JUSTIFICATION

REMOVAL OF INTERNAL CASEMENT WINDOWS

107 HIGH STREET, LINDFIELD, HAYWARDS HEATH, RH16 2HR

Proposed ground floor plan

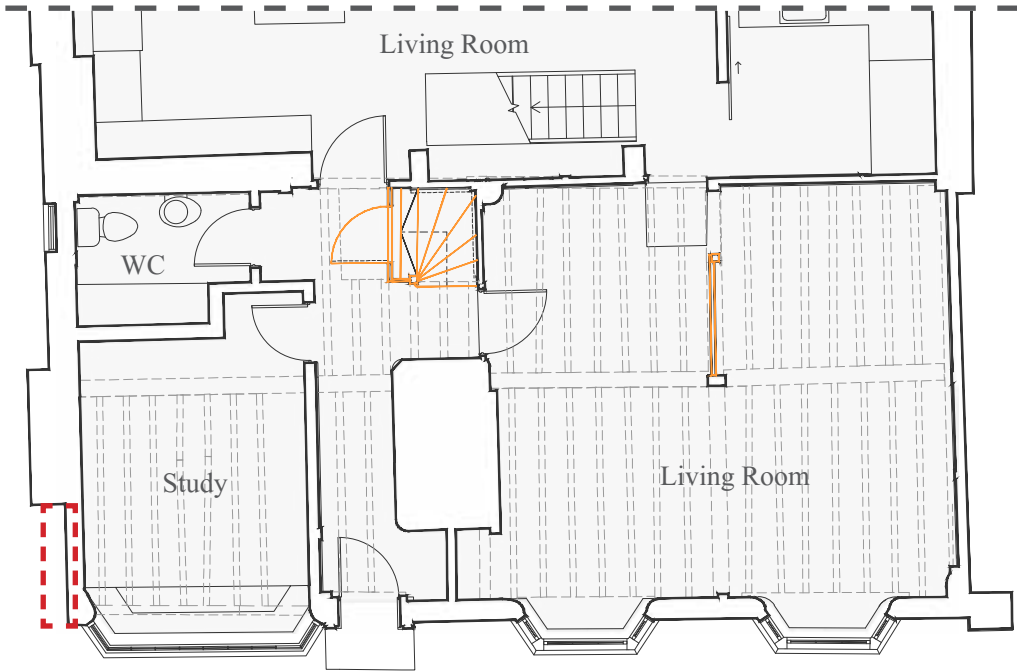
It was approved for the existing timber weatherboarding to the return corner of the front (East) and side (South) elevation to be extended down to ground level.

Leaving it as it is retains the legibility of a possibly truncated timber jetty as well as the exposed timber framing and brick nogging to this return elevation. Under-implementation of this change is preferable in heritage terms.

Proposed roof plan

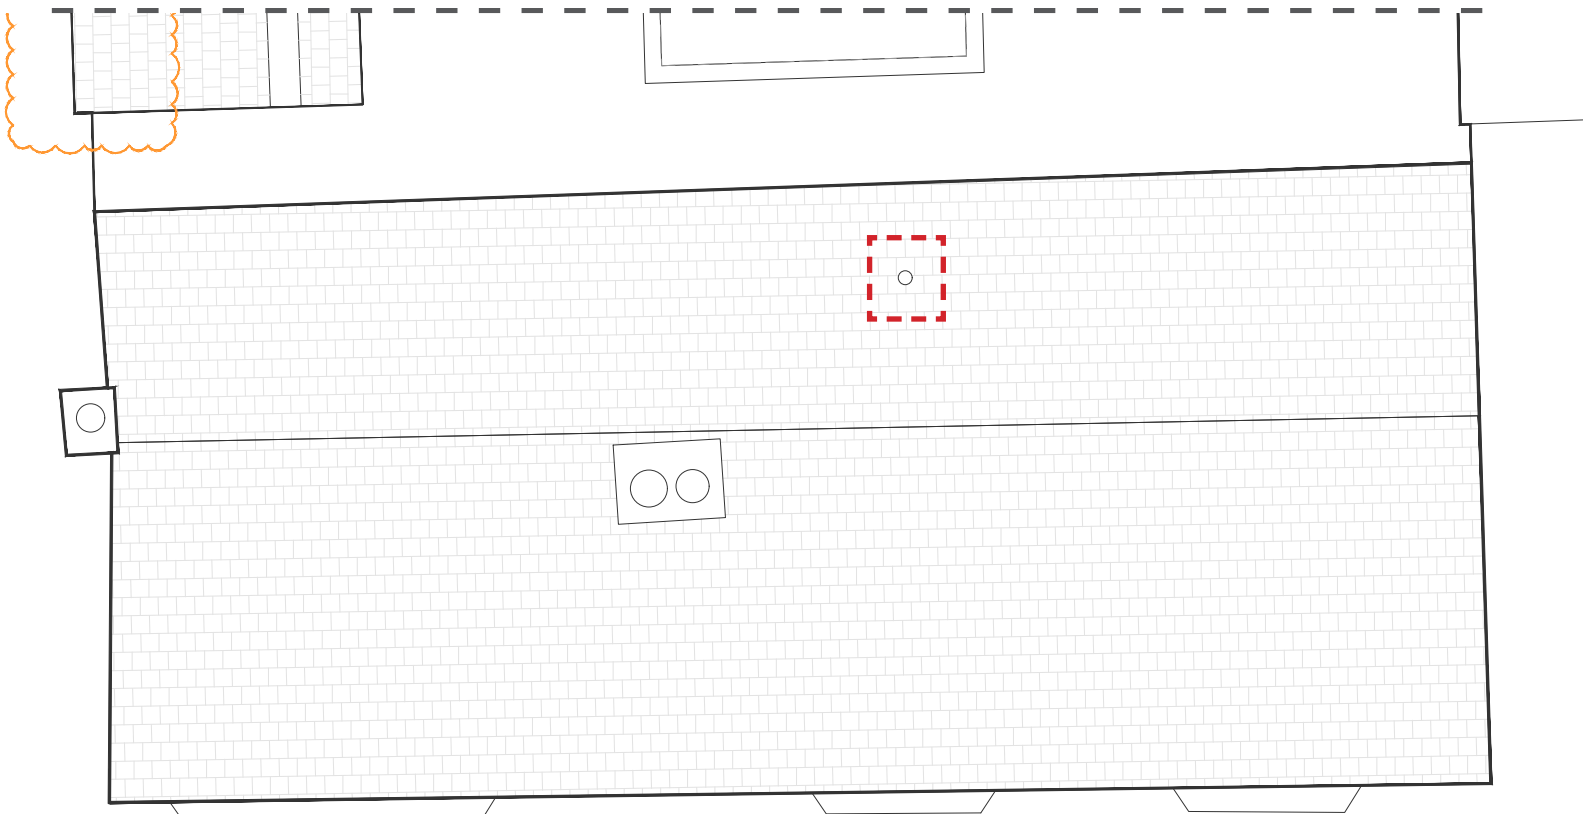
A new water tank, boiler and associated flue have been installed in the attic. It forms a part of retrospective works applied for under this application.

The flue is a 100mm diameter pipe penetrating through the roof with flashing around it to ensure watertightness. It projects up circa 300mm from the face of the roof tiles but not above the main ridge line and is not visible from the front elevation.

Water cylinder is approx. 600mm diameter and stands on its own supporting timber base spreading the weight over the historic floor joists below.

Proposed West Elevation

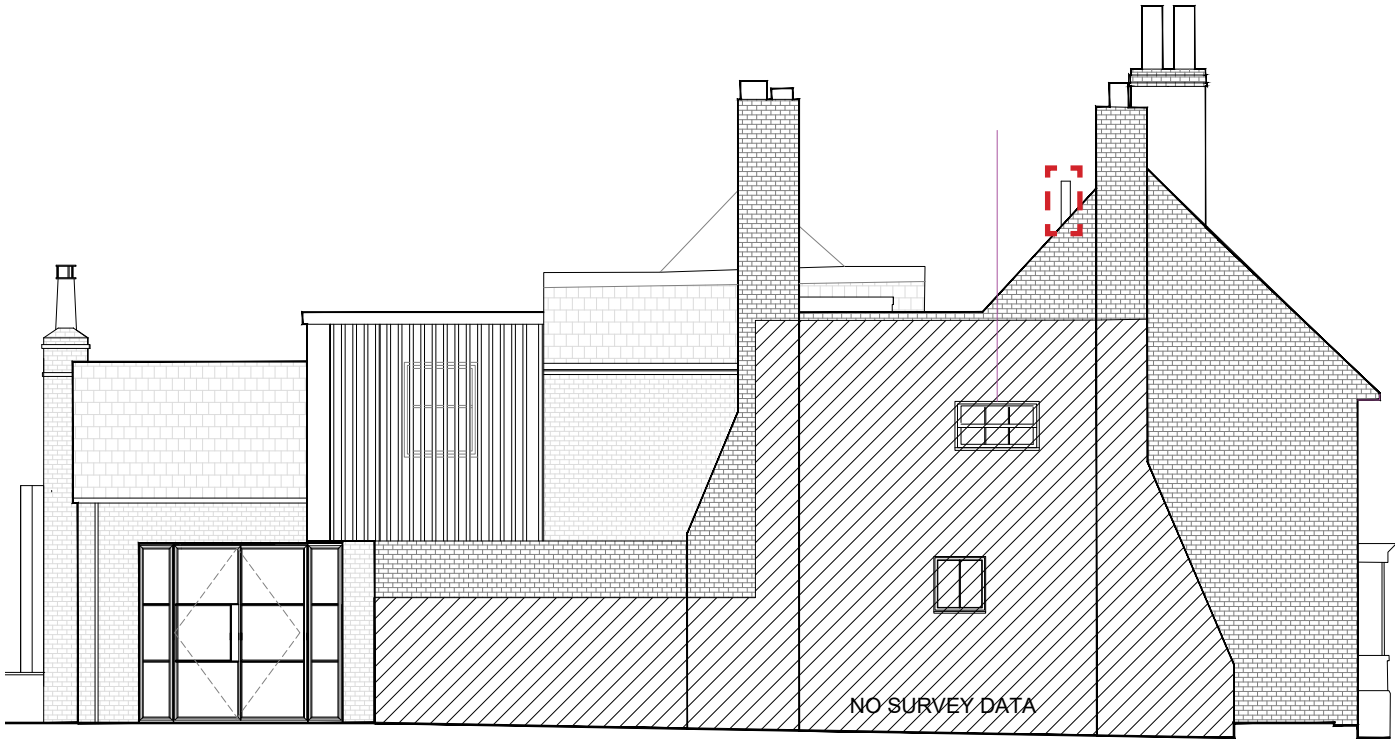
As can be seen from the drawings below, the position of the boiler flue on the rear sloping roof pitch is such that it is not visible from the principal elevation.

Proposed ground floor plan

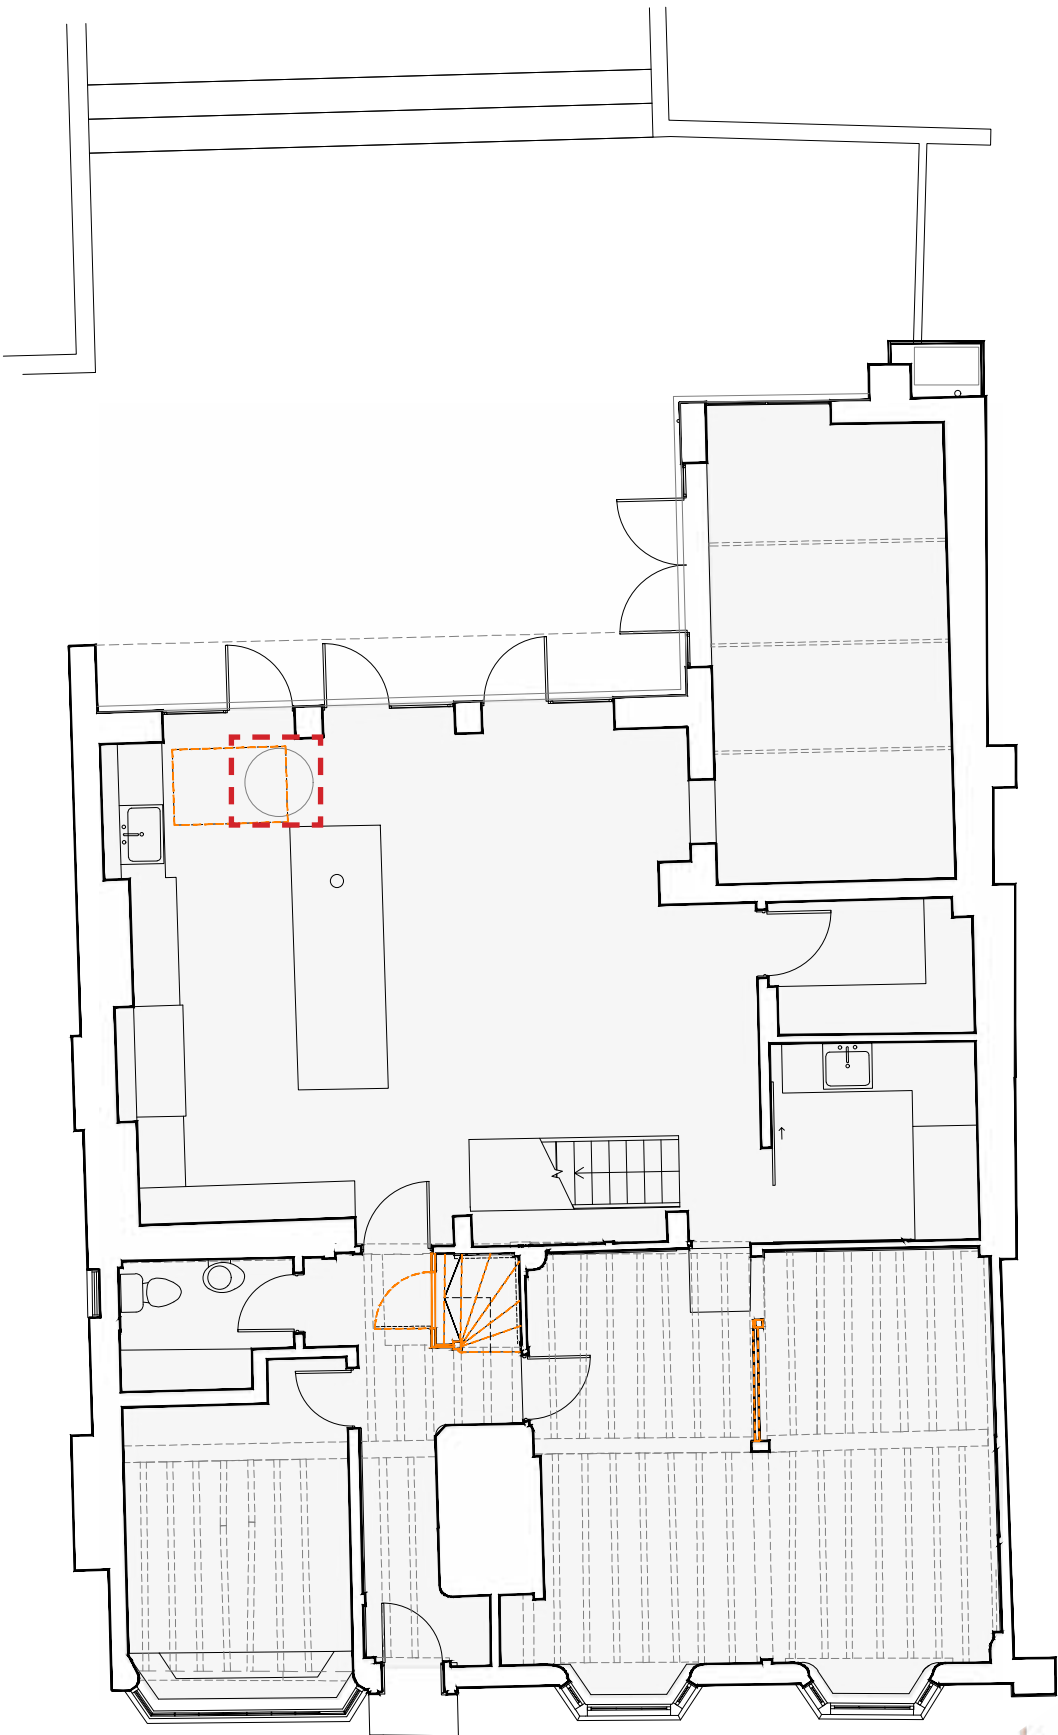
A historic well was discovered during the course of construction works and retained as an internal feature within the rear extension. Historic fabric of well has been retained. New brick lining placed in front on a lintel within the well. A glass cover was added, allowing full view into the well. The following works were undertaken:

Following inspection, it was considered important that the well's original construction and natural performance were preserved without interference. The well structure, formed within the natural sandstone and local limestone geology, was therefore left entirely intact. No tanking, cementitious coatings, or intrusive works were carried out, and the original water bearing environment and weeping masonry were not altered in any way. Instead, a light touch structural approach was adopted. As a result, the historic fabric, natural drainage behaviour, and geological context of the well remain preserved in situ. - SHDR Ltd (Further details provided within the Appendix.)

109 High Street south gable wall re-pointed in lime mortar

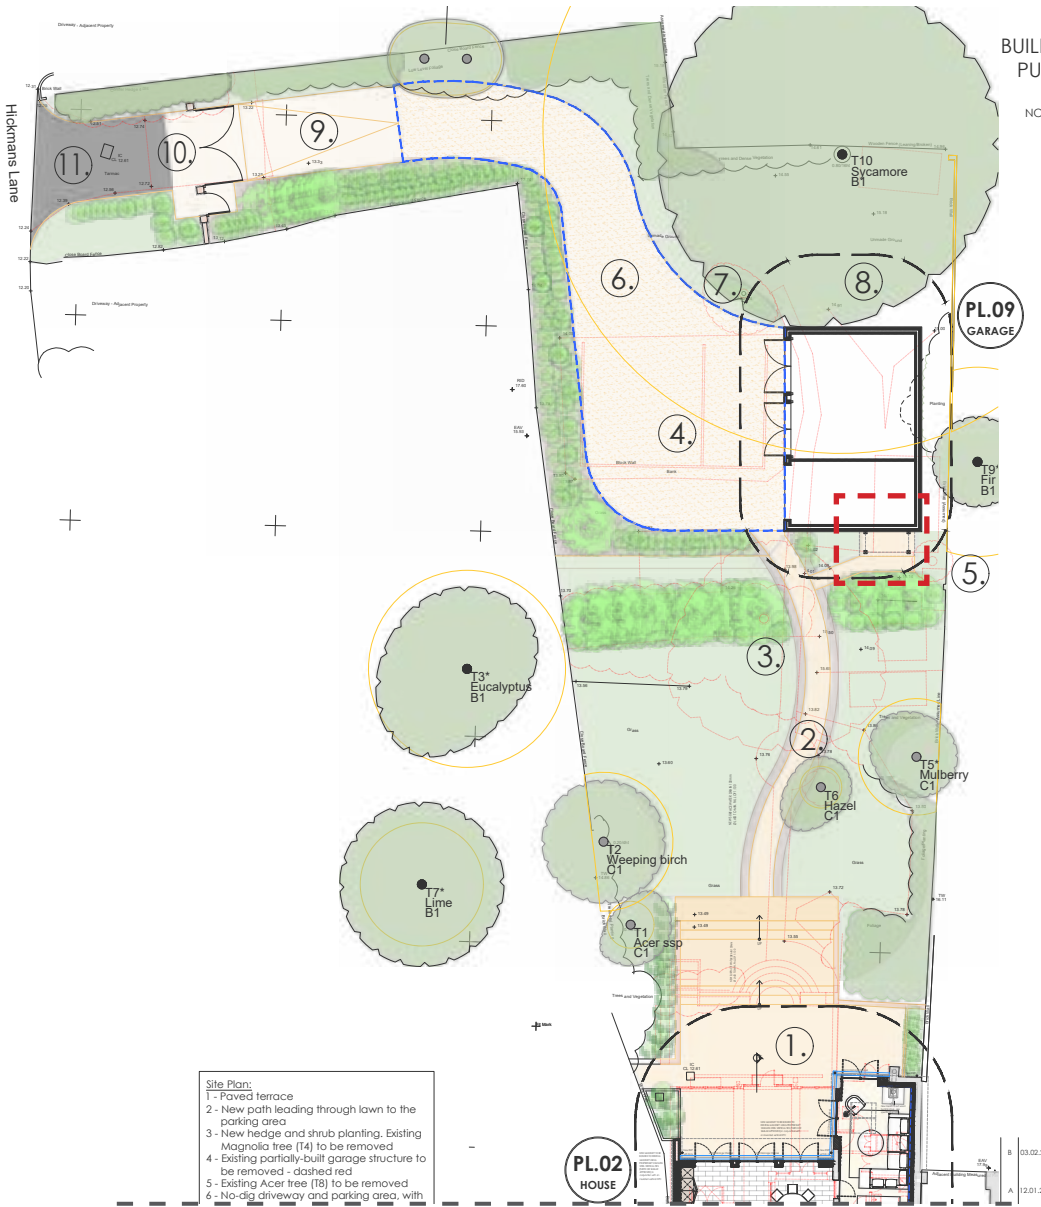
Following the changes to the roof above the bathroom, the applicant offered to re-point the southern gable of the neighbouring listed property at 109 High Street.

This work was carried out using lime mortar, rejuvenating the now more exposed brickwork façade, improving the fabric quality of the adjacent listed building, ensuring its longevity for years to come.

1. Approved Site Plan - submitted drawings under application DM/22/3694 & DM/22/3695 (planning approved).

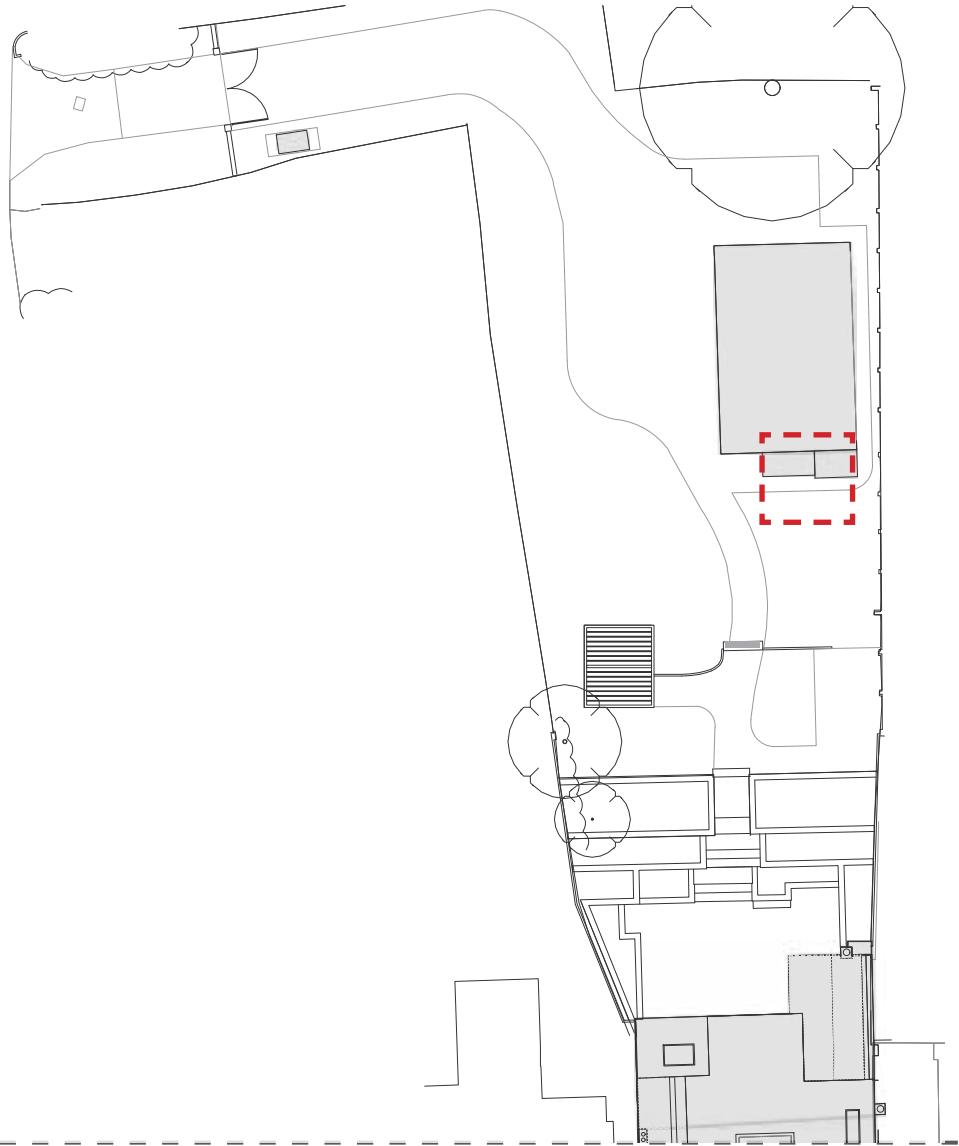
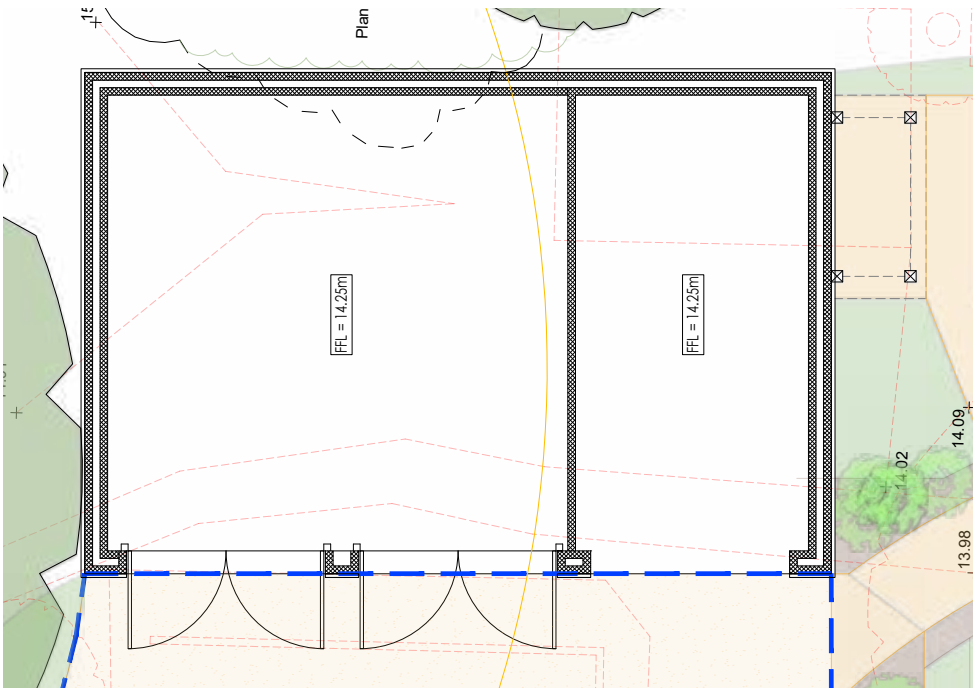
The garage has been constructed with minor variation to the approved scheme - the approved log store was constructed lower and in shifted location (centre of the elevation instead of side).

1. Approved Garage Drawings

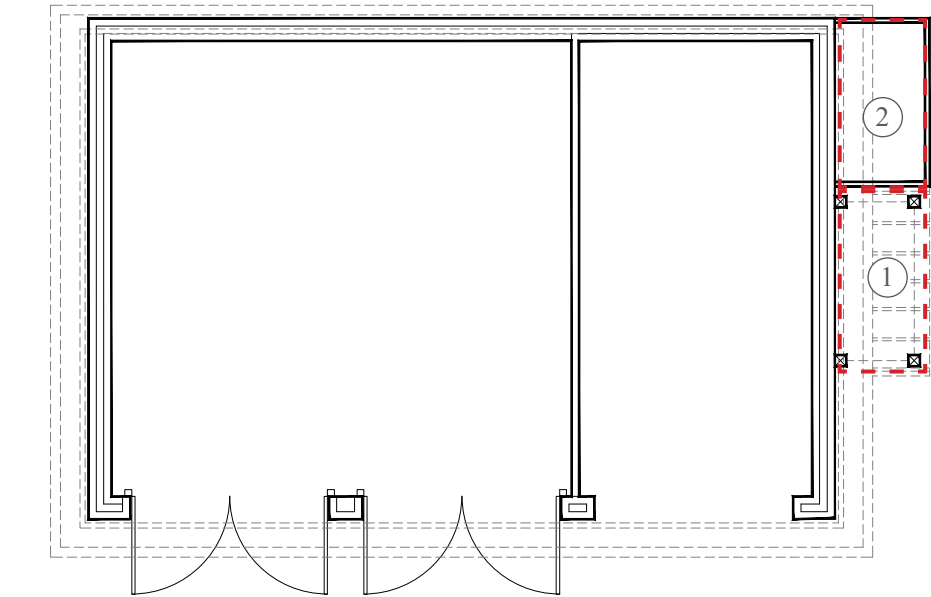
- Highlighted area of deviation
- 1 Timber log store
- 2 Irrigation tank enclosure
